Addendum No. 1
W13305177
Revised Pedestrian Crossing
TEDD Approval: *gah 6/2/06*

SHA STATE OF MARYLAND
DEPARTMENT OF TRANSPORTATION
STATE HIGHWAY ADMINISTRATION
OFFICE OF TRAFFIC & SAFETY
TRAFFIC ENGINEERING DESIGN DIVISION
US 50 BUSINESS (SALISBURY PKWY) @ DELAWARE AVE.
SALISBURY, MD

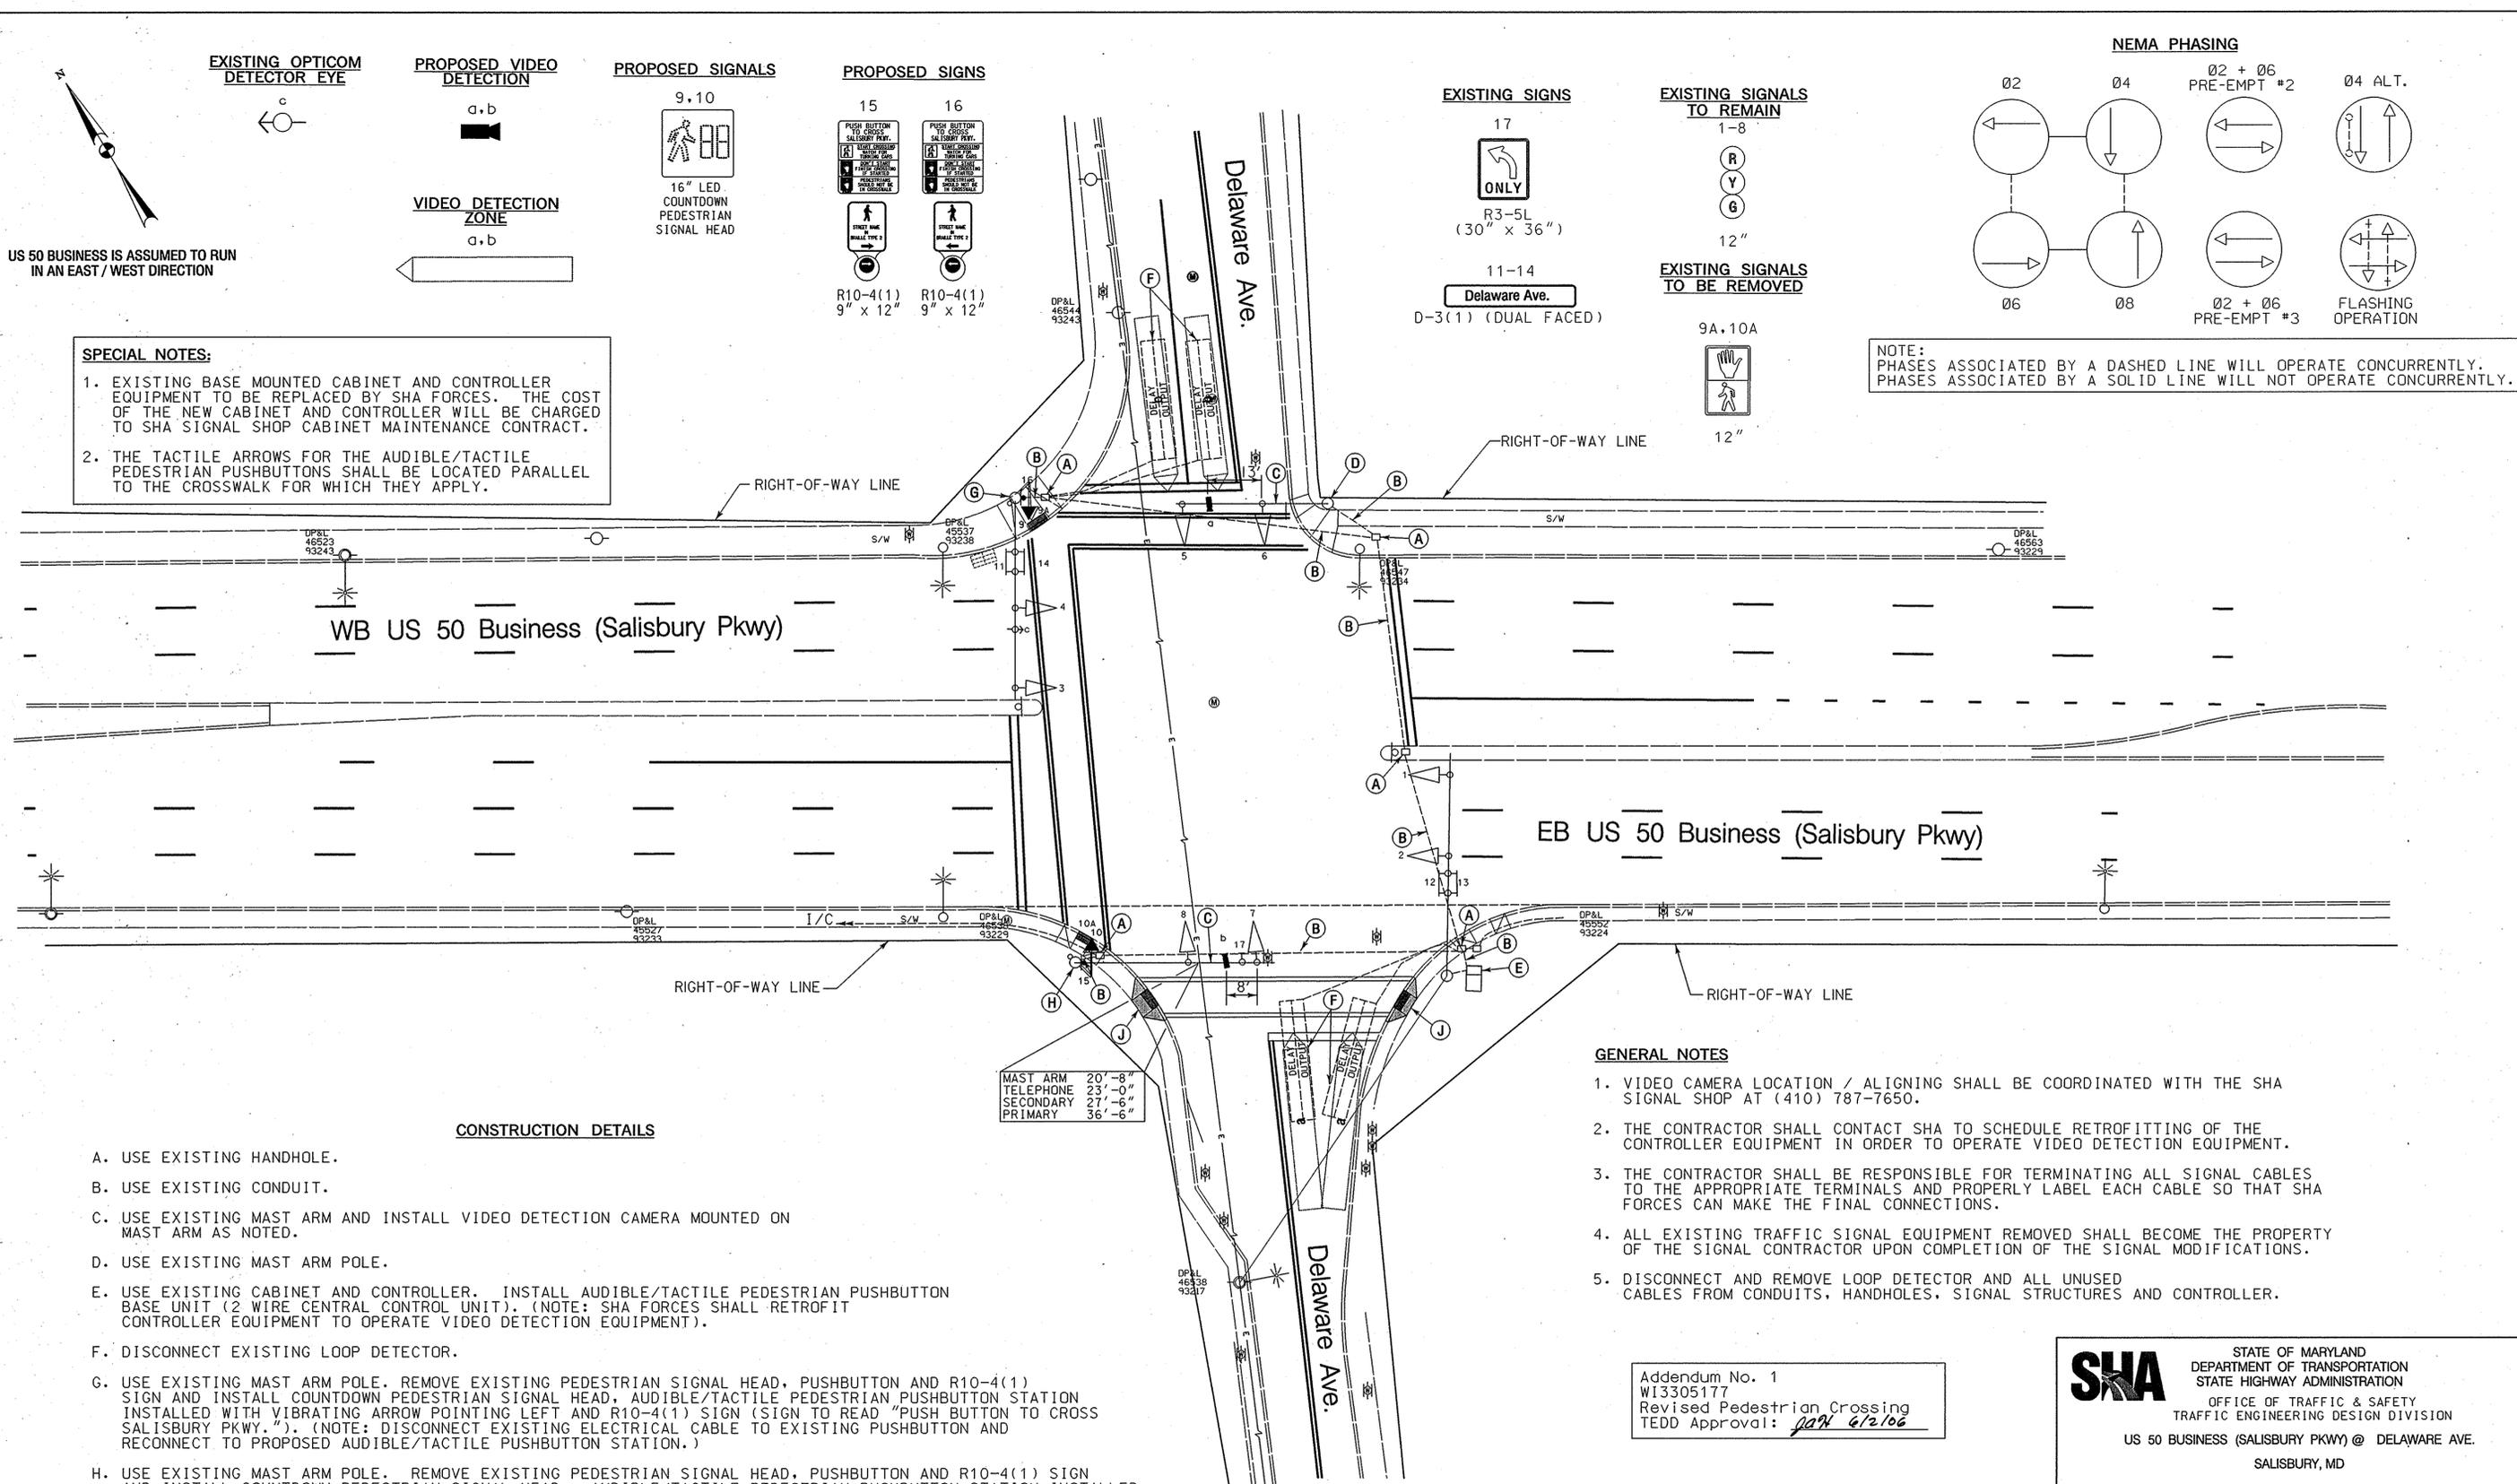
Whitman, Reardon + Associates, LLP 801 South Caroline Street Baltimore, Maryland 21231 (410) 235-3450	APPROVALS TEAM LEADER ASST. DIV. CHIEF DIVISION CHIEF OFFICE DIRECTOR	REVISIONS ① INSTALL VIDEO DETECTION CAMERAS AND APS TMS #462 CONTRACT NO. W13305177 4/14/2006 NML BRD WM JAH DJD LTH ② OMIT S.B. RIGHT LANE DELAWARE AVE. LOOP DETECTOR W1 632-502-185 1/5/1986 ERS SR	SIGNALIZATION PLAN SCALE 1" = 20' DATE 3/5/04 CONTRACT NO. W1-632-502-185 DESIGNED BY THOMAS ZAYDEL COUNTY WICOMICO DRAWN BY G. HALLAMEYER LOGMILE 22005015.71 CHECKED BY DENNIS DODA JR. T.I.M.S. NO. H462 F.A.P. NO. TOD NO. DRAWING NO. TS-1963B OF SHEET NO. 2 OF 12
	PLOTTED: 6/2/2006 FILE: N:\3155607\CADD\PSG-P002_US50DEL.DGN
